VCS VERIFICATION/CERTIFICATION REPORT

HEBEI KANGBAO SANXIATIAN WIND FARM PROJECT IN CHINA

1 December 2009 to 25 November 2010

REPORT No. 2011-9482

Figure 1 Diagram of meters installation

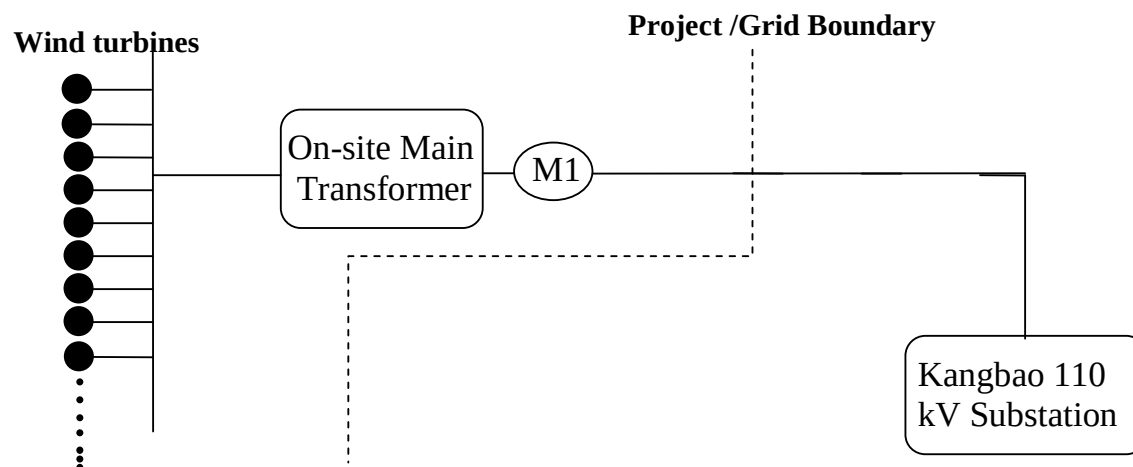
The installation of the monitoring meter M1 is shown in Figure 1 below. The main meter M1 (Serial No. 09070111440058) with the accuracy level of 0.2s was installed at the high voltage of the 110 kV transformer at project site and belong to the project owner. The accuracy 0.2s of M1 is consistent with the monitoring plan of registered PDD /2/ and meets the requirement of power industry code (DL/T 448-2000) /28/ and thus deemed acceptable by DNV. The main meter M1 was used by project owner to measure the electricity exported to the grid as per PPA /8/, which is fully consistent with PDD /2/. The readings of meter M1 were continuously measured and monthly recorded by the project owner. On the last day of every month, the project owner and the grid company jointly read the main meter M1 and after the readings were confirmed by both sides the grid company issued the monthly electricity sales receipts /12/.

The installation and operation of the monitoring meter M1 was checked through visual inspection at the project site during site visit. The monitoring meter was consistent with the monitoring plan contained in the registered PDD /2/. The meter was calibrated once a year /14/ which is consistent with the monitoring plan of the registered PDD /2/.
